SUBJECT: "Semiannual Radioactive Effluent Release Rept for Jan-June  
 1987." W/870828 ltr

# PROOF AND REVIEW

Marked up Proof  
& Review to be  
Applicants Proposed

FIGURE 6:2-1  
OFFSITE ORGANIZATION

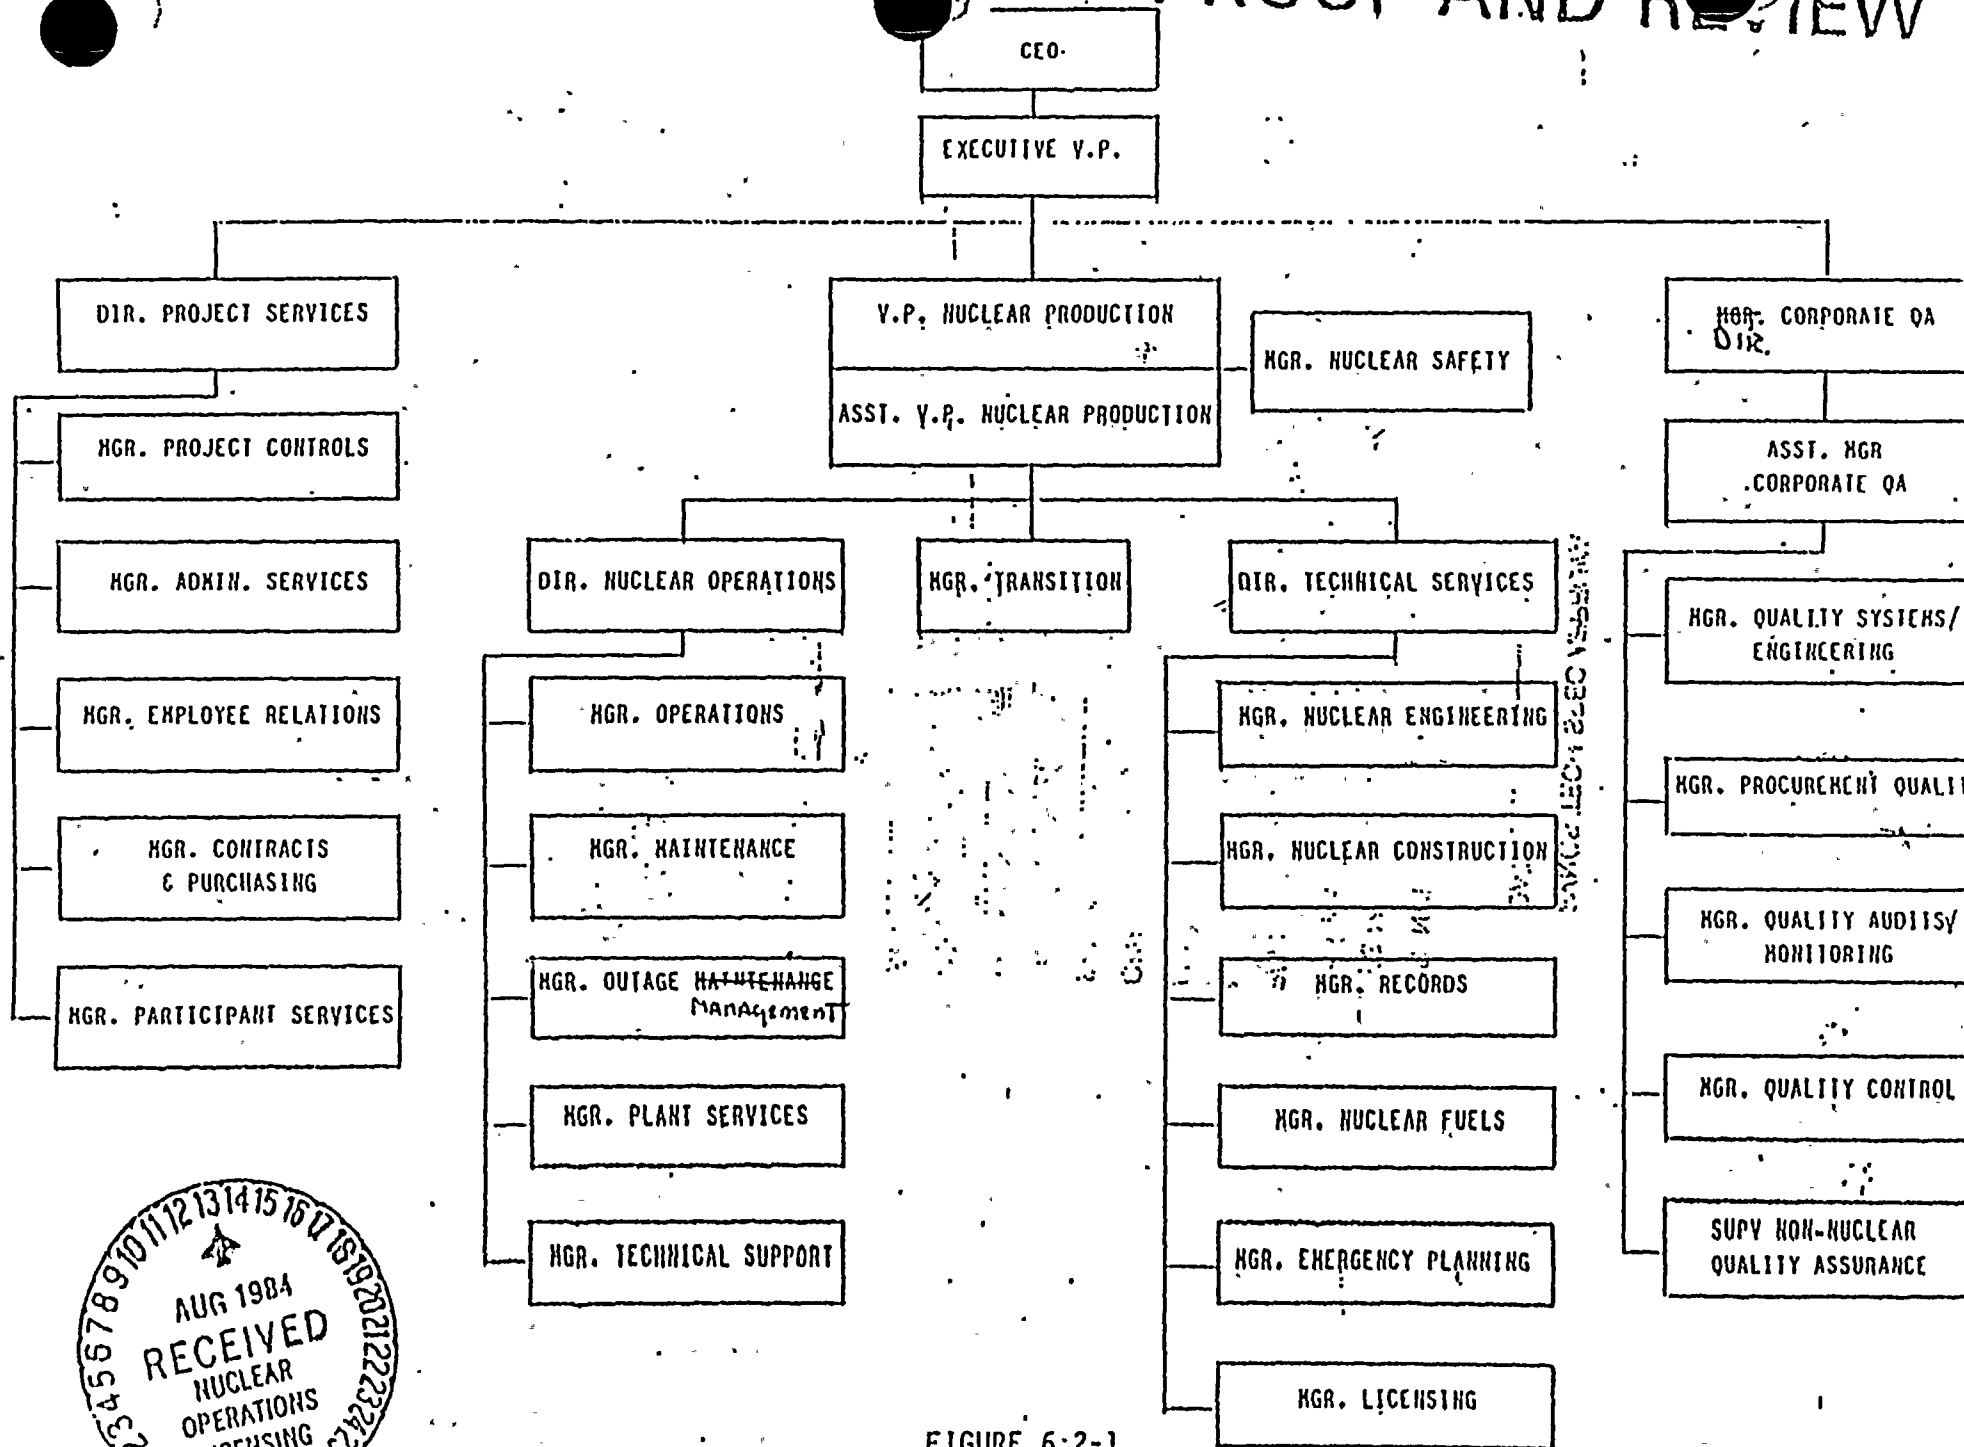
6.2.1 The offsite organization for unit management and technical support shall be as shown in Figure 6.2-1. OR AS SPECIFIED IN THE FSAR.

FIGURE 6.2-2  
ONSITE UNIT ORGANIZATION

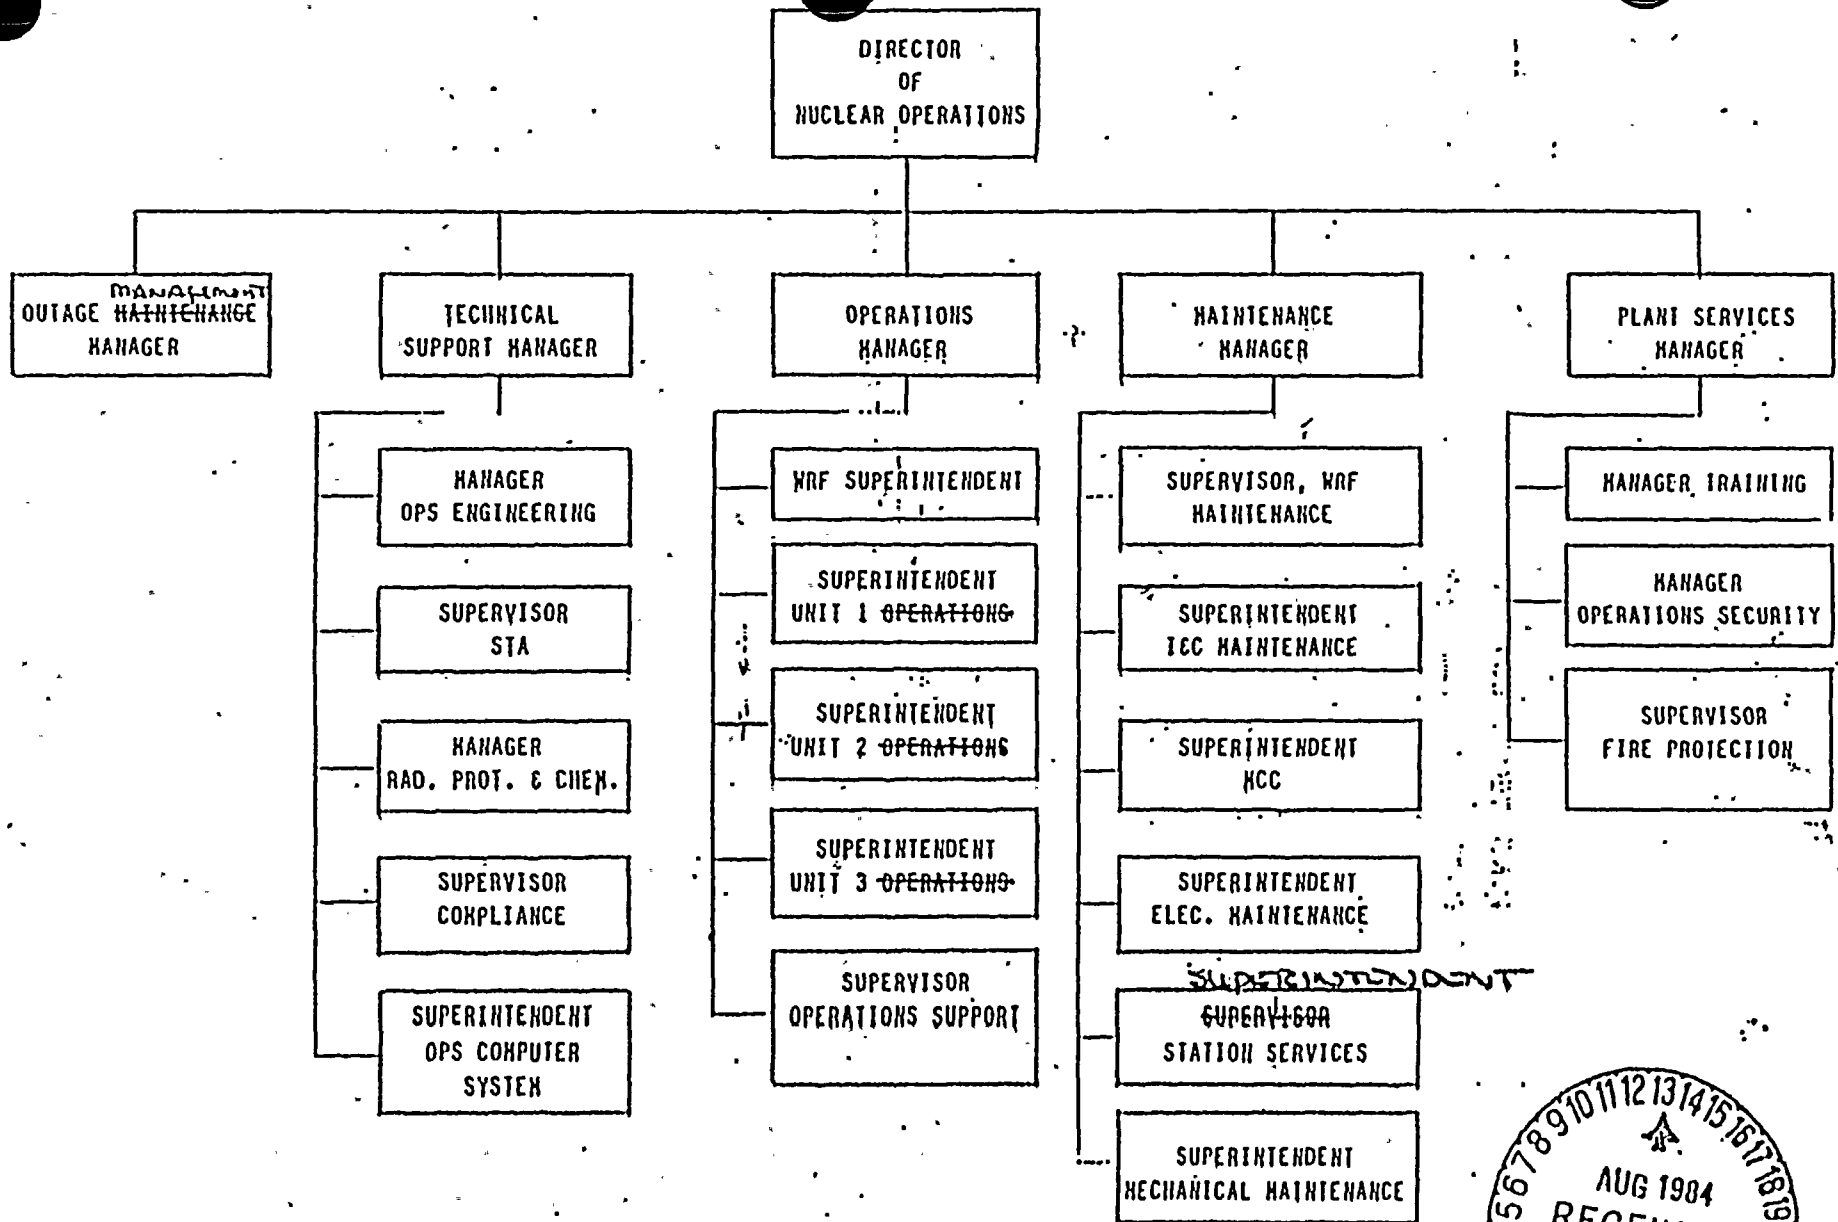
6.2.2.1 The unit organization shall be as shown in Figure 6.2-2 and: OR AS SPECIFIED IN THE FSAR
